Architectural Review  
and Historic Preservation Board  
Agenda Report

Meeting Date 01/16/2019

File: AR 18-17

RE: Architectural Review 18-17 (Pabbi Nord Apartments)  
824 Nord Avenue, 043-220-019

# ARCHITECTURAL SITE PLAN Rev.

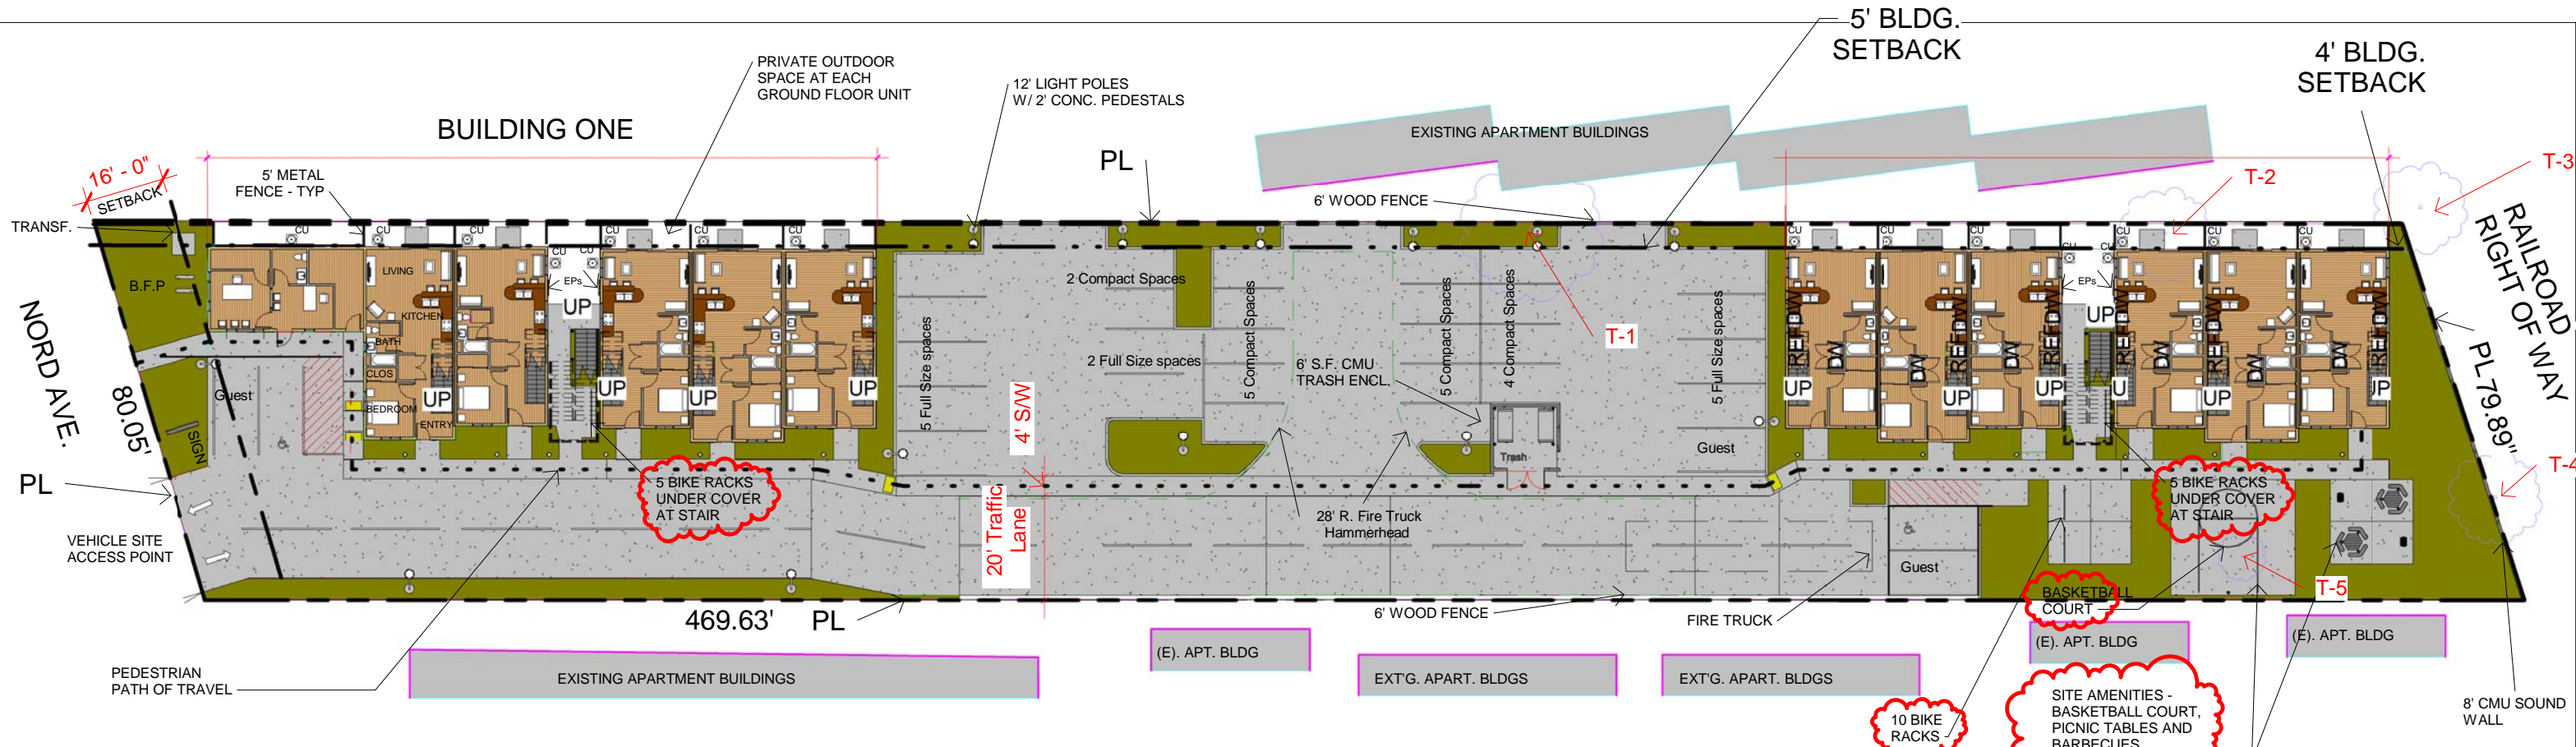
1. ***Provide additional details regarding the amenities proposed within the shared recreational areas.***

**Response:** The attached site plan drawings have been clarified and indicate that the proposed amenities area at the rear of the site will include a basketball court, cement picnic tables and barbeques (see **Attachment B**, Updated Site Plan).

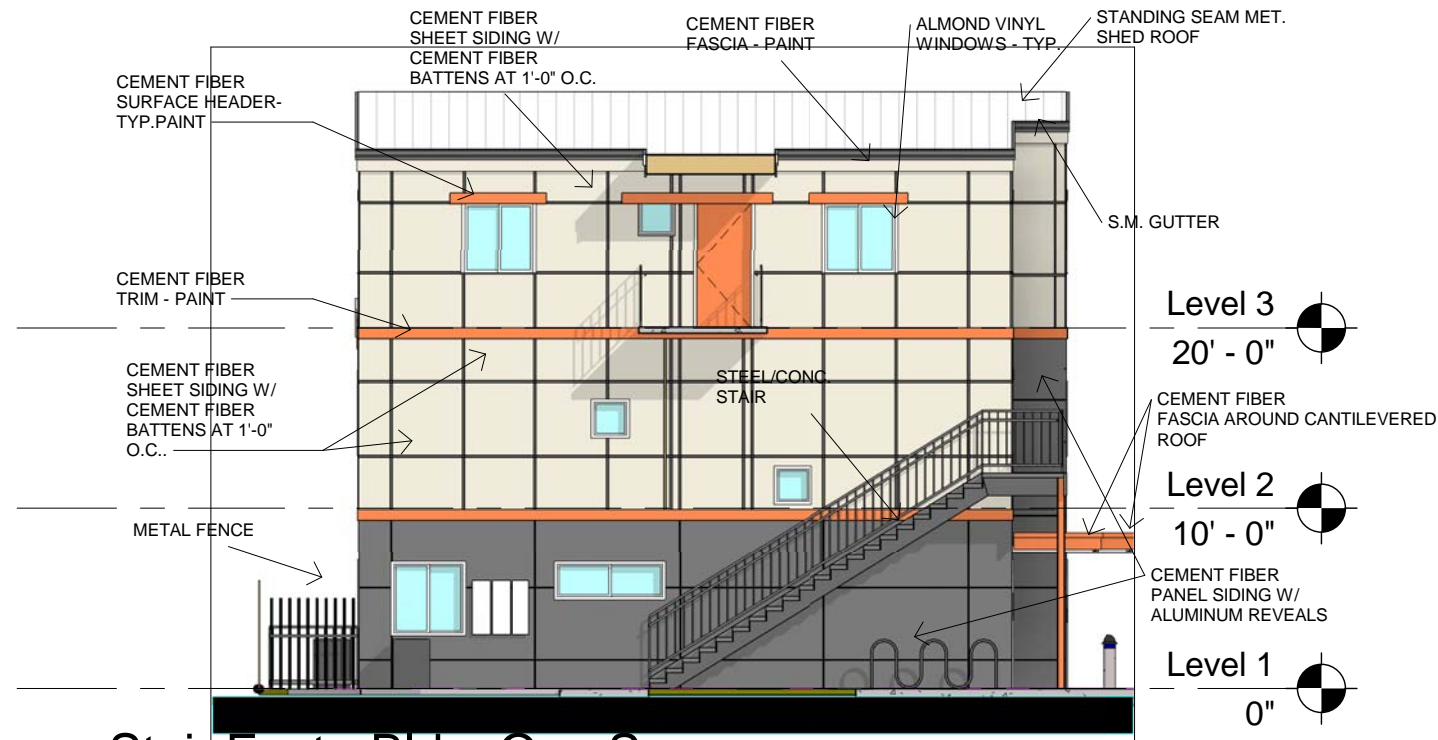
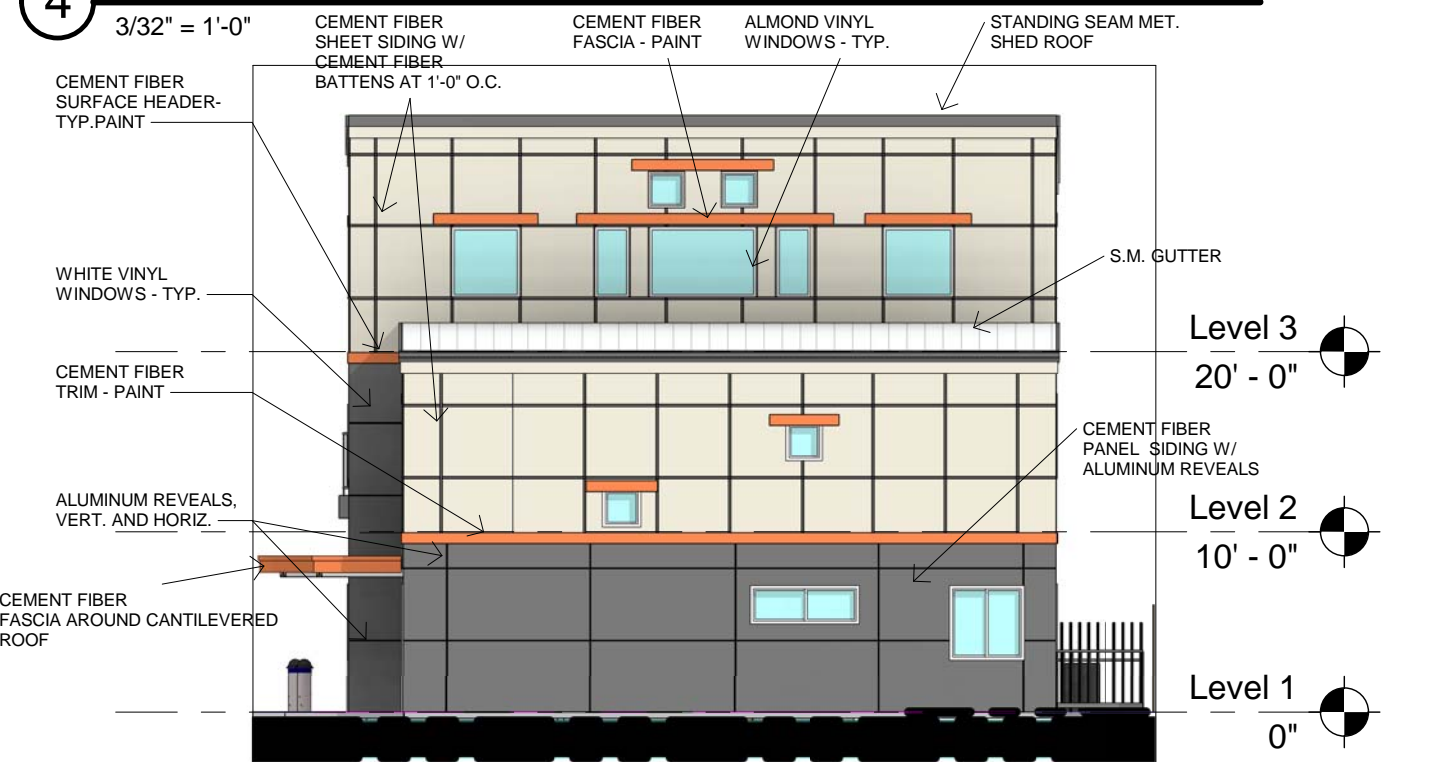
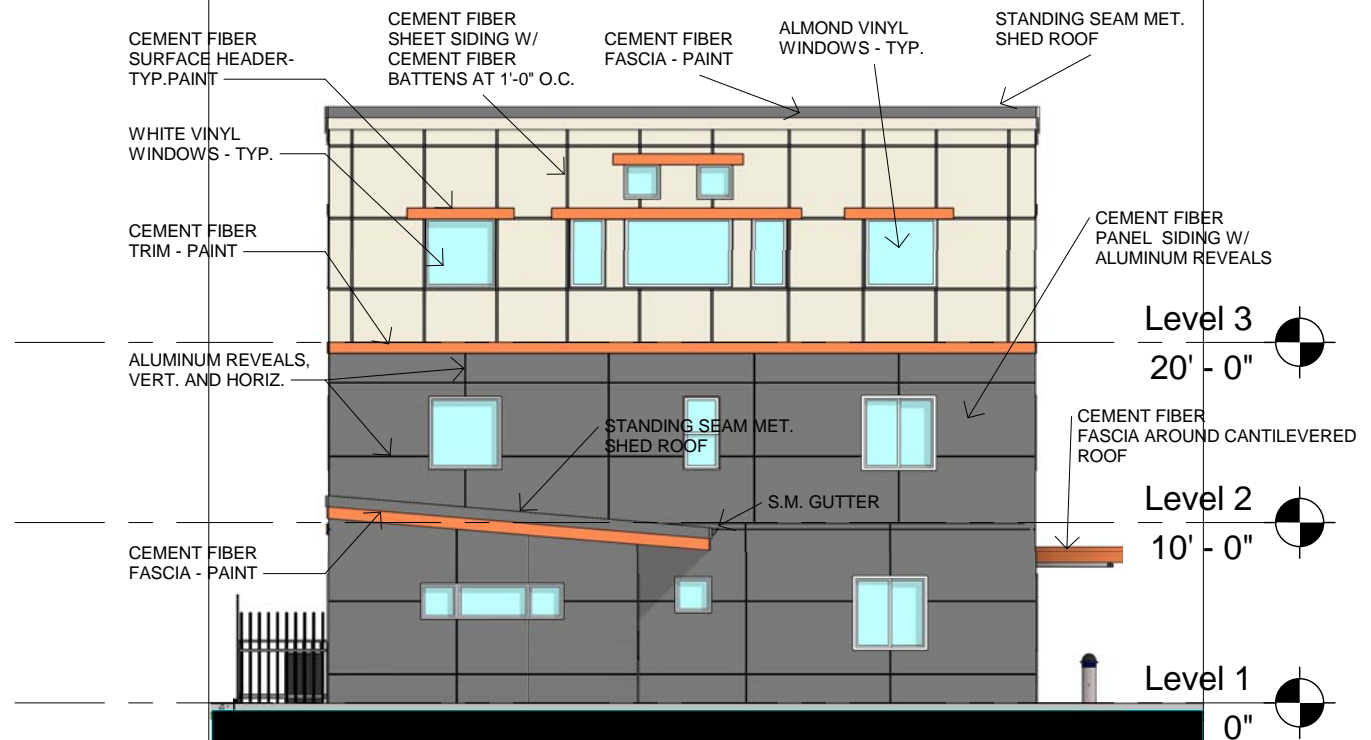
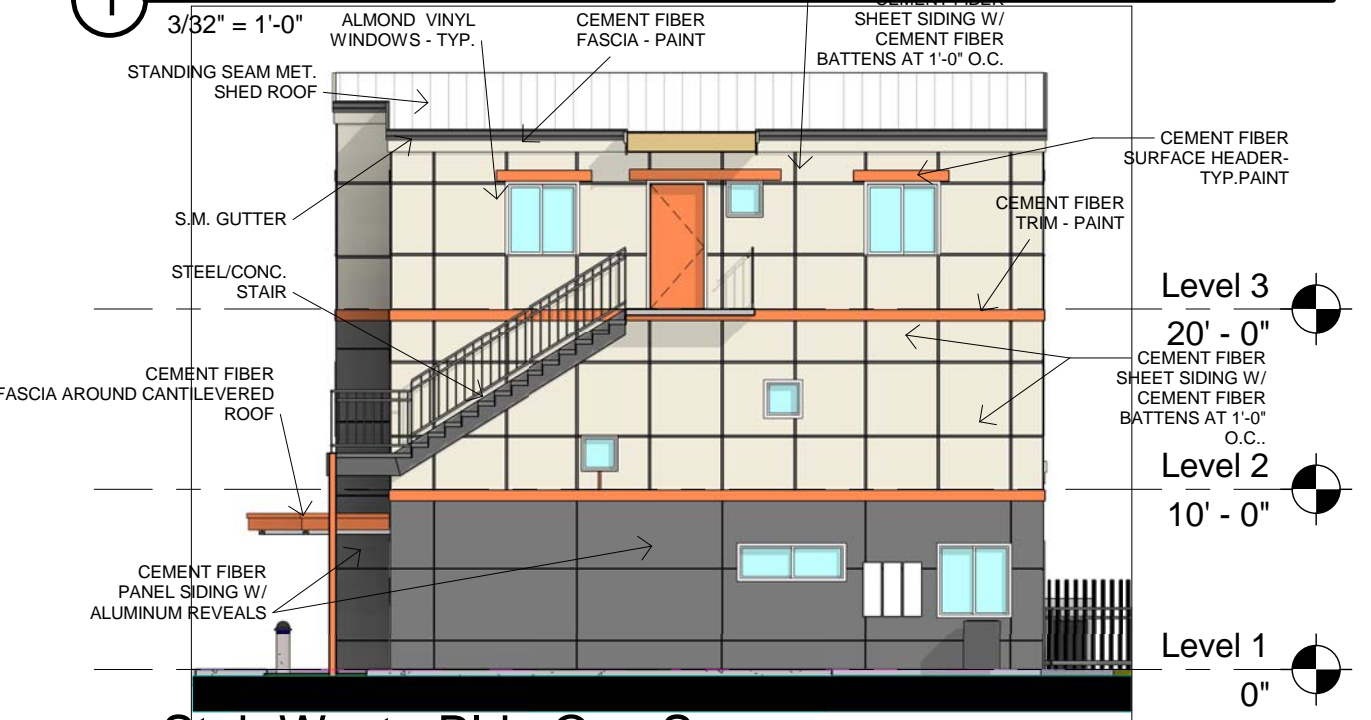
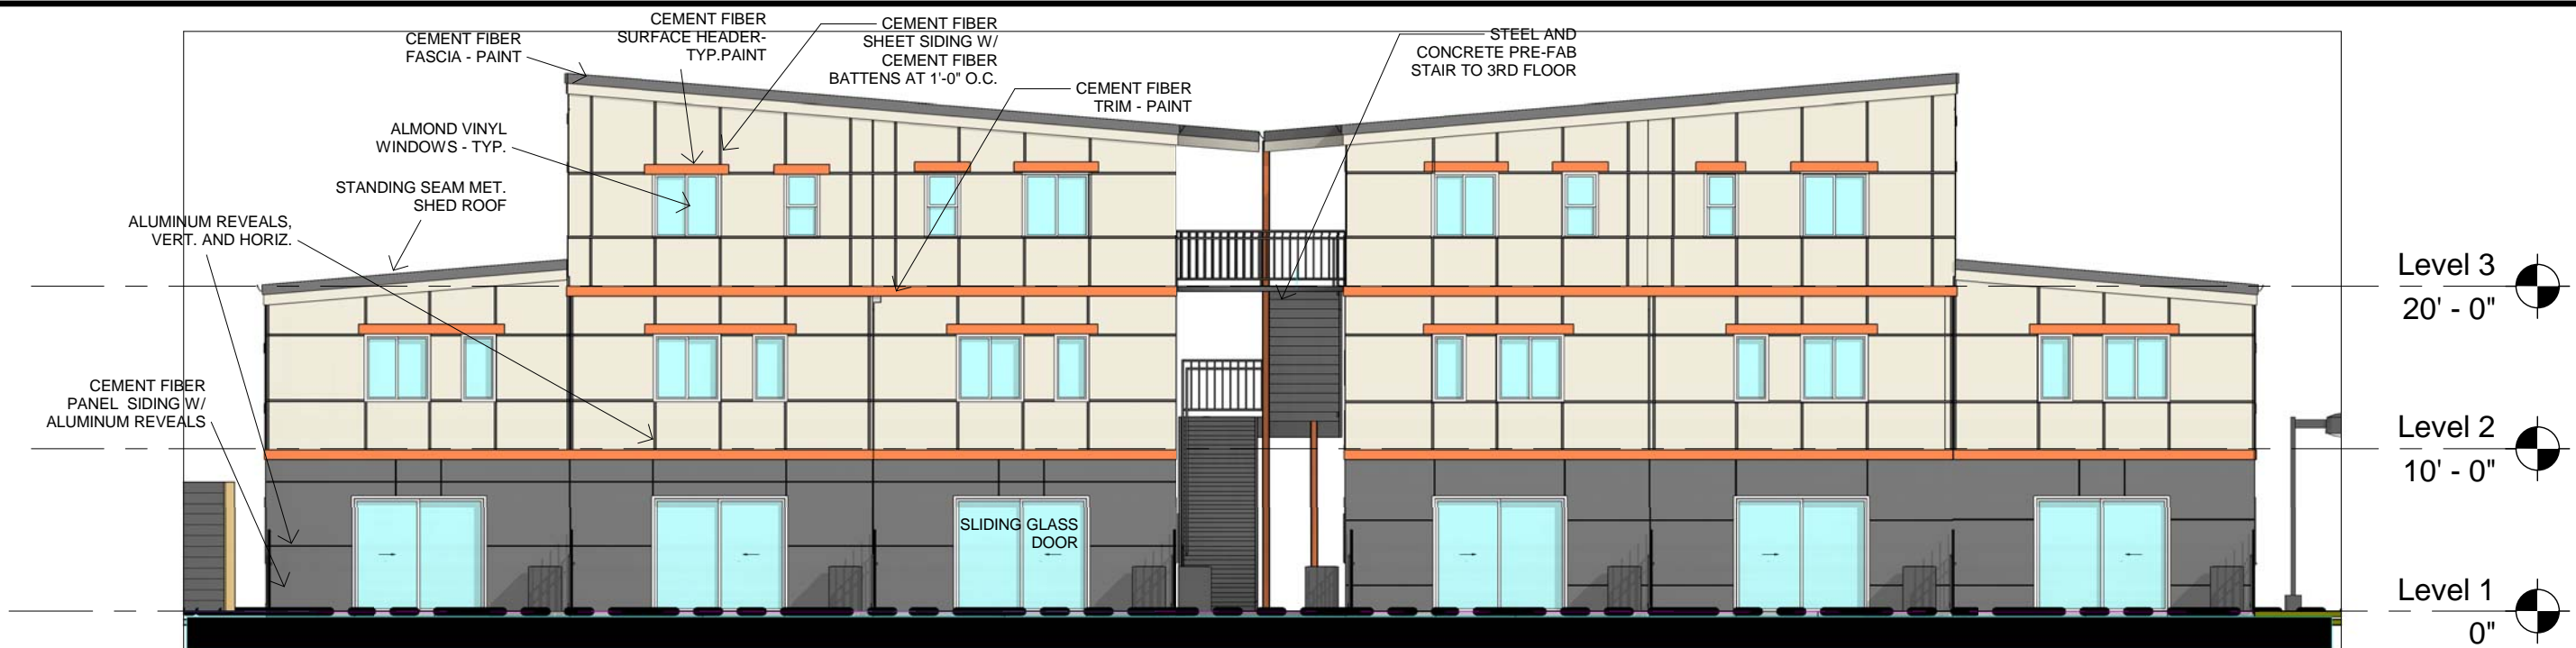
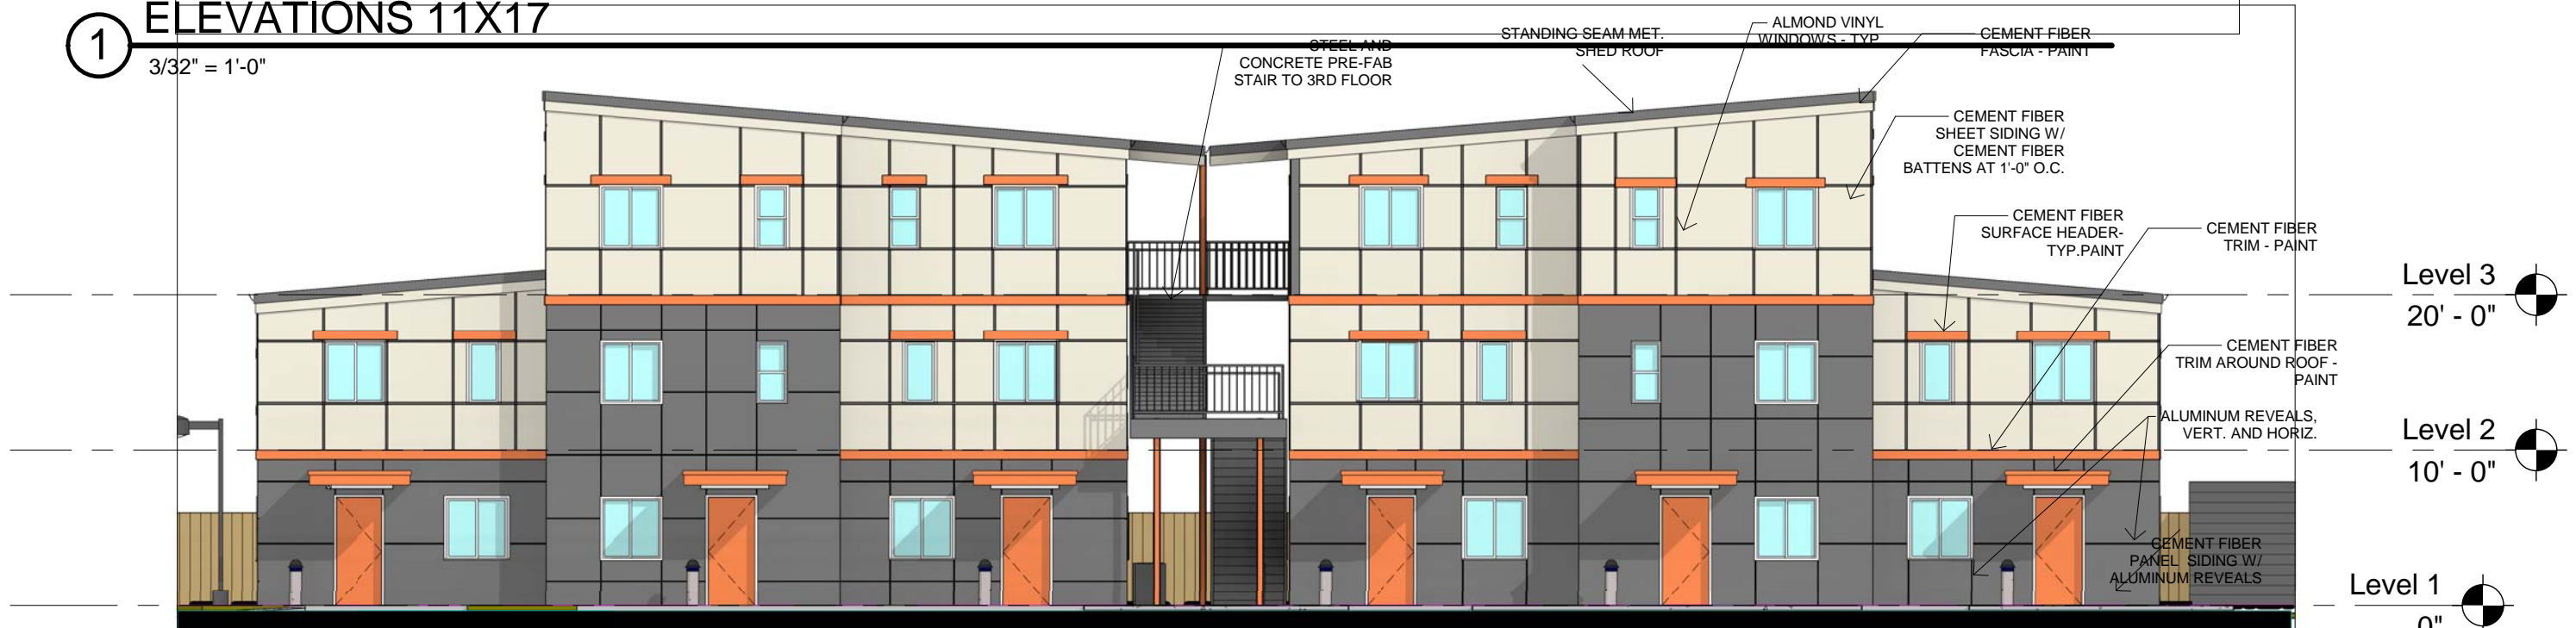
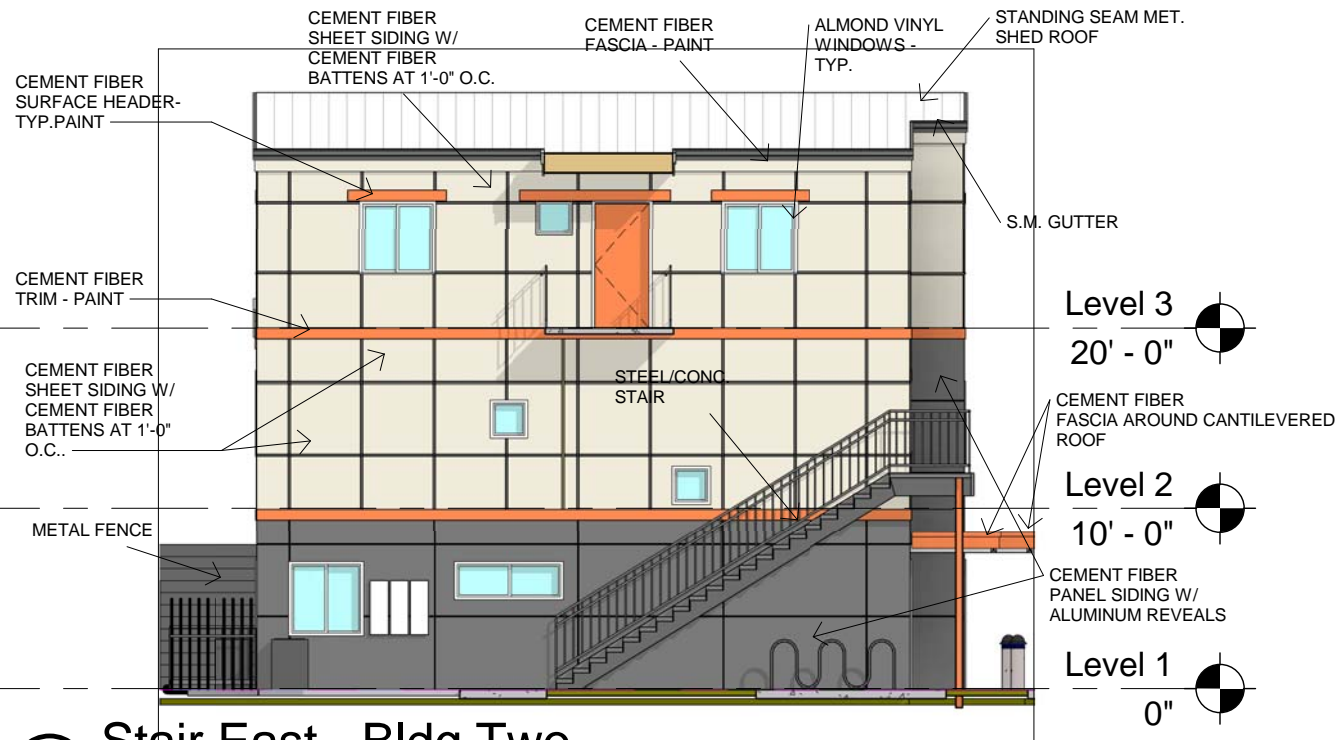
2. ***Explore alternative color scheme.***

3. ***Explore a possible redesign of the building's roof forms.***

**Response:** The applicant has opted to use the proposed orange color for doors, awnings and trim elements. The building's main body would be beige and gray (see **Attachment C**, Updated Color Elevations and **Attachment D**, Updated Color Board). Second and third story exterior finishes that previously gave a "shipping container" appearance have been modified to a sheet siding cement fiber panel, giving the building's a uniform appearance.

**Response:** The applicant has indicated that this sloping, “butterfly” roof form was selected because of the ductless HVAC system used for the building. The sloped roof allows for the elimination of wasted attic space that would come with a gable roof (see **Attachment E**, Aerial View of Roof). Similar roof-forms can be found along the Nord Avenue corridor, such as Brentwood Apartments and Campus Walk Apartments.
